**ROCKY FLATS ENVIRONMENTAL
TECHNOLOGY SITE**

**771 Closure Project
Decommissioning Operations Plan
Modification 5**

August 8, 2003

Figure 4. Building 771 First Floor Plan Demolition Concept

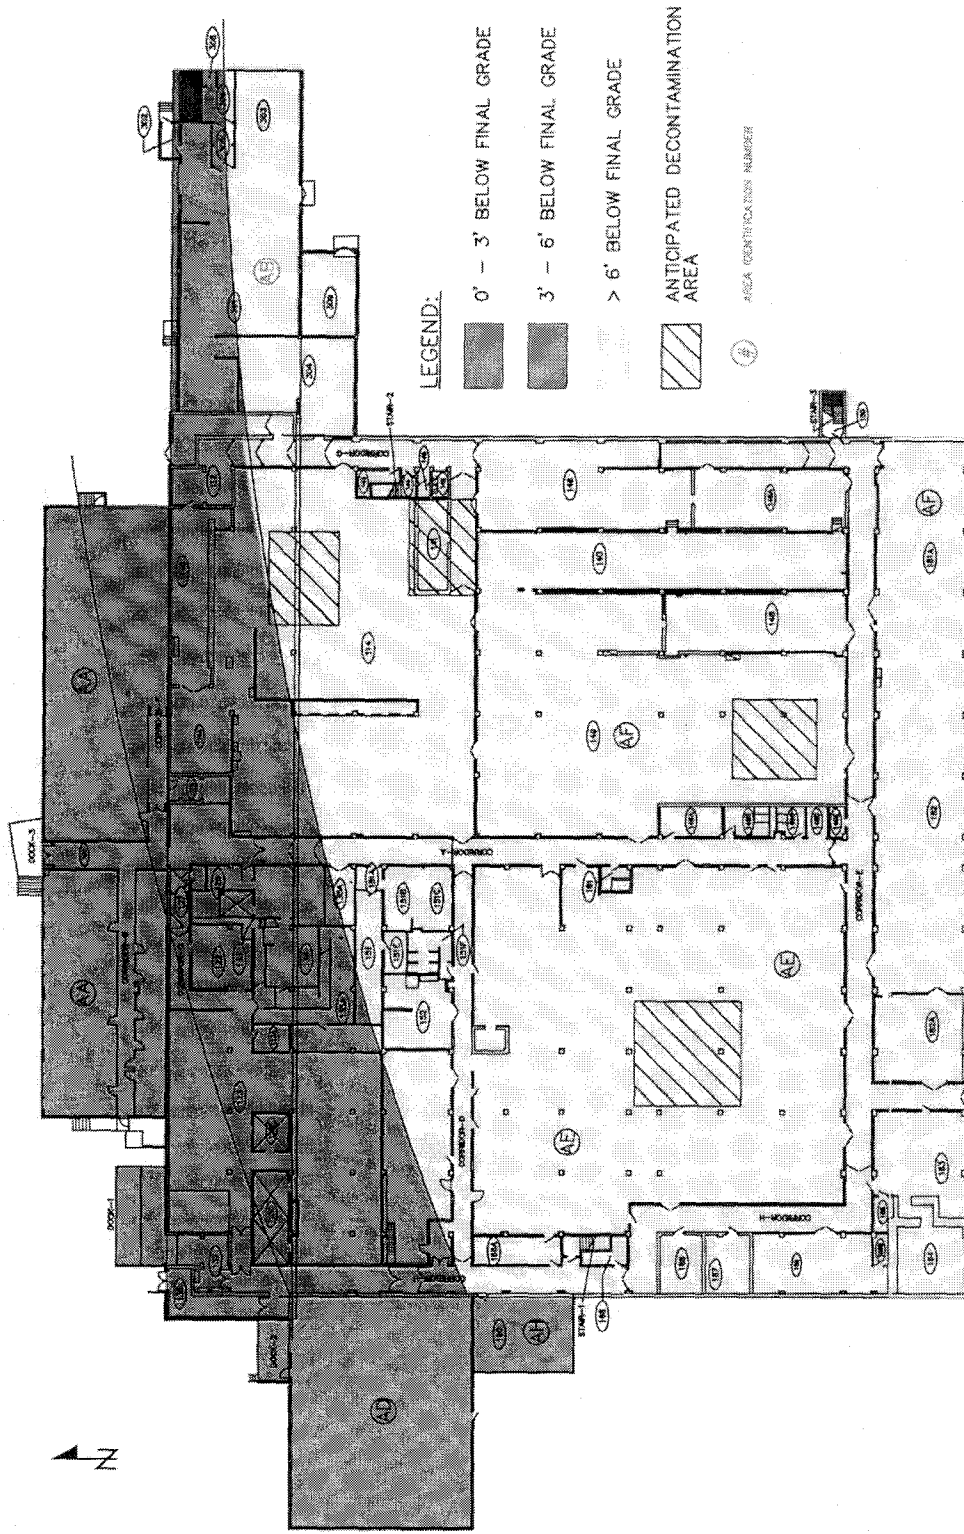
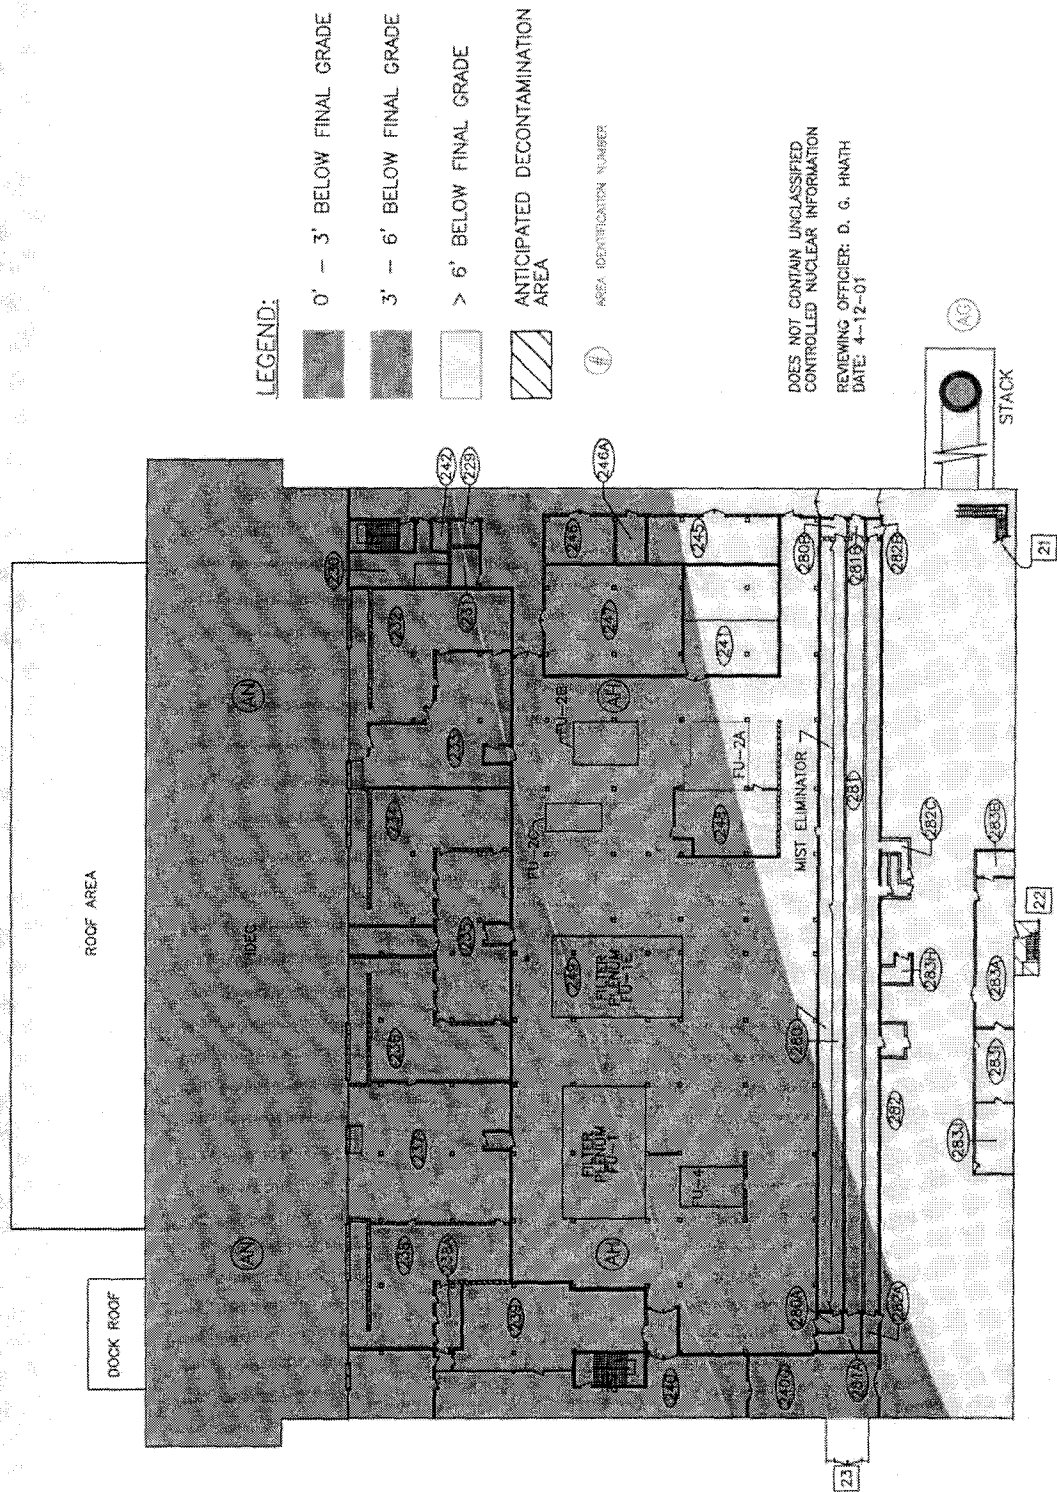
7	Figures 4 and 5 Update figures to reflect current proposed land configuration.	These figures will be updated for the final version of the document.
8	Figure 5 This figure is difficult to understand and needs, at the least, the floors labeled.	Floor labels will be added to the figure.
9	Section 4.7.1 It is indicated that steel plates may be utilized to "encapsulate" the remaining contamination. Steel plating must be removed and cannot be left after demolition. It is recommended that Instacote be considered rather than steel plate.	Instacote will be evaluated. There seems to be no technical reason for removing the steel plates. If the structural steel can remain in the facility, the minor amount of steel plates should have little or no adverse affects. However, steel plates will not be used, and the document has been revised.

Figure 5a. Profile of Building 774 Final Grade

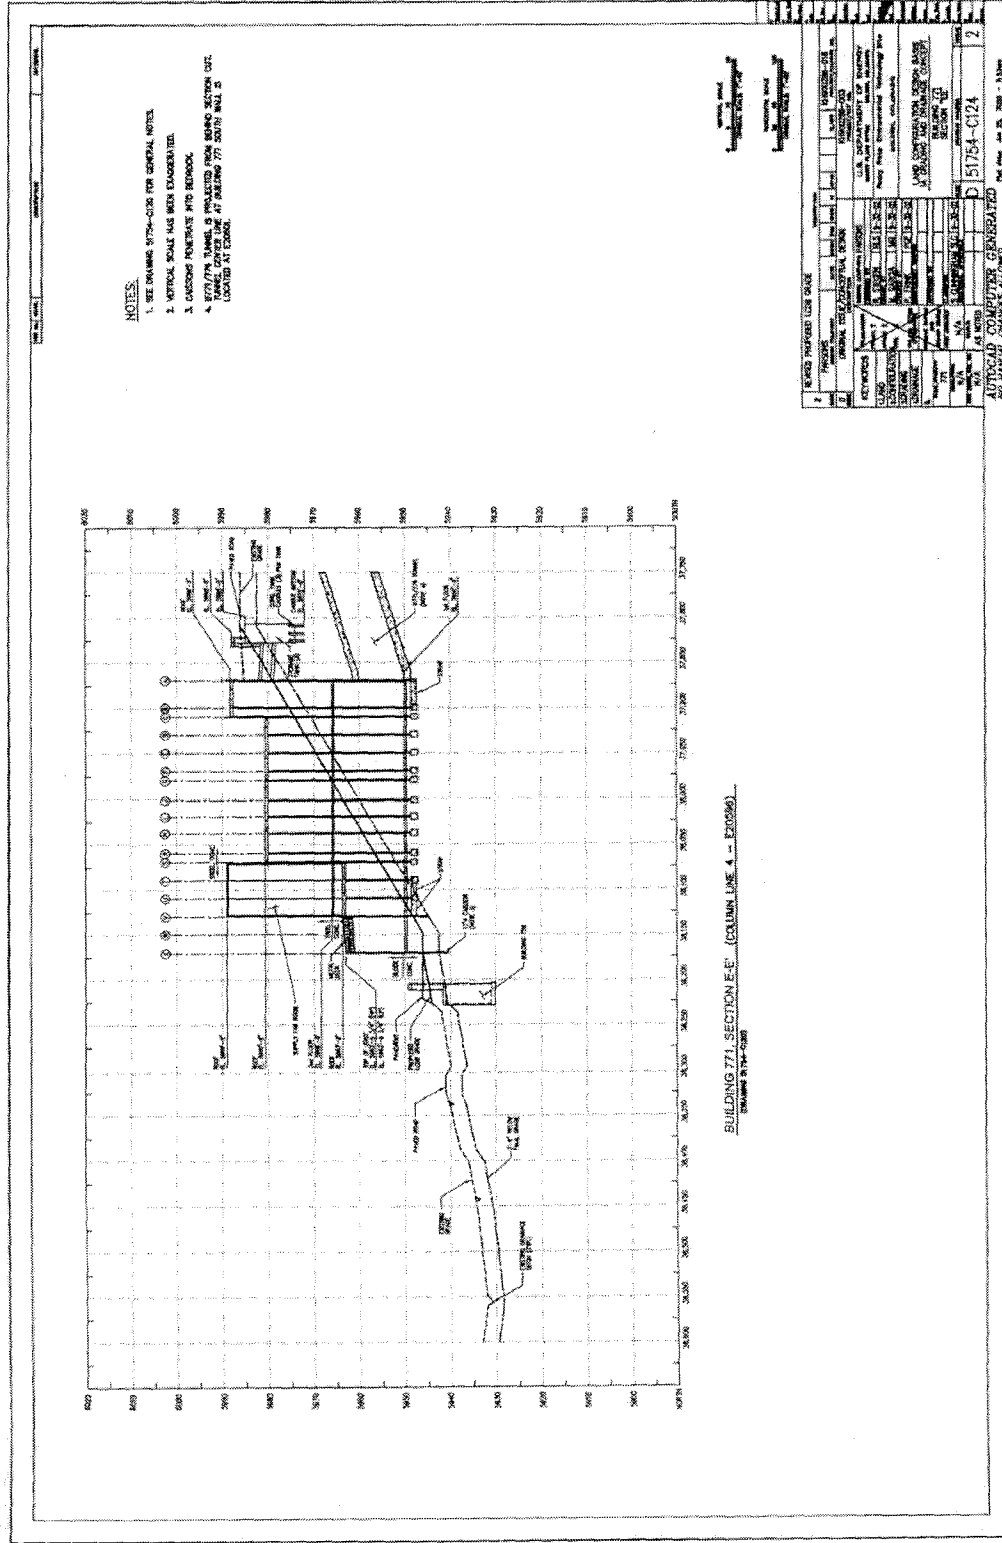
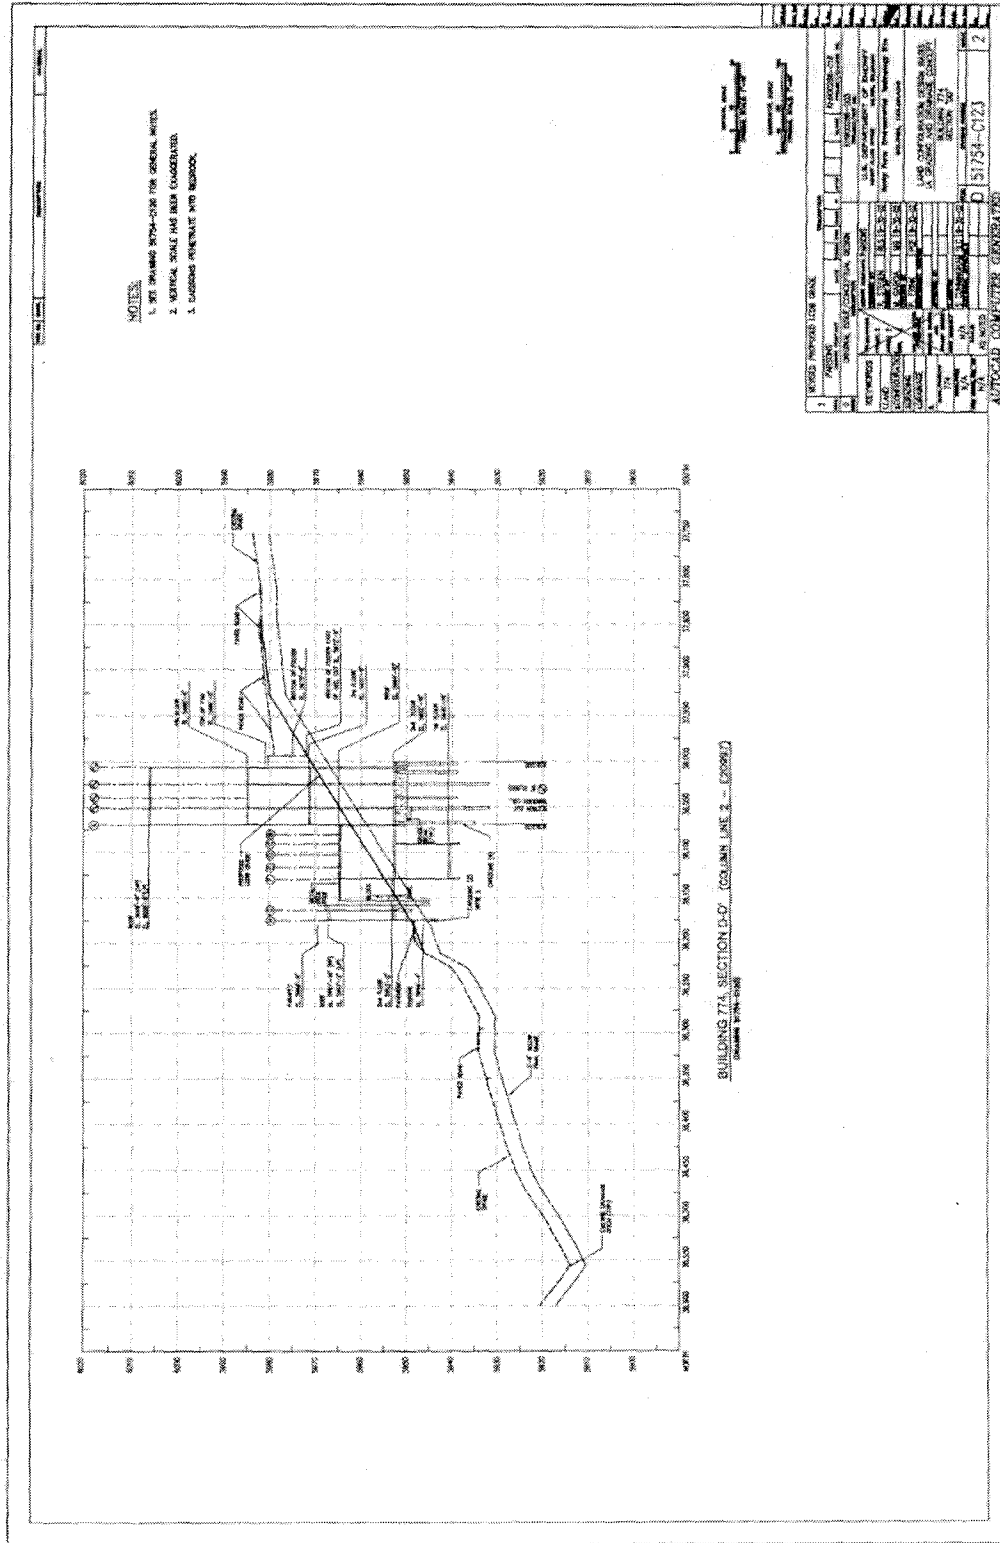
5	<p>Figures</p> <p>The text in Section 4.7.1.8 (Demolition of the Main Building 771 Structure) describes the planned three-sided configuration for the Building 771 foundation area after demolition, and states that "Figures 4 and 5 provide an aerial view of this concept." Figures 4 and 5 provide a useful aerial view, but they do not show the three-sided configuration referenced. During the Coalition staff briefings, Site representatives distributed side-view diagrams of the post-demolition condition of B771 and B774. It would be helpful to include these diagrams so that the reader has a better understanding of the depth of the buildings and how much of the structures will be demolished.</p>	<p>These figures were added to the document.</p>
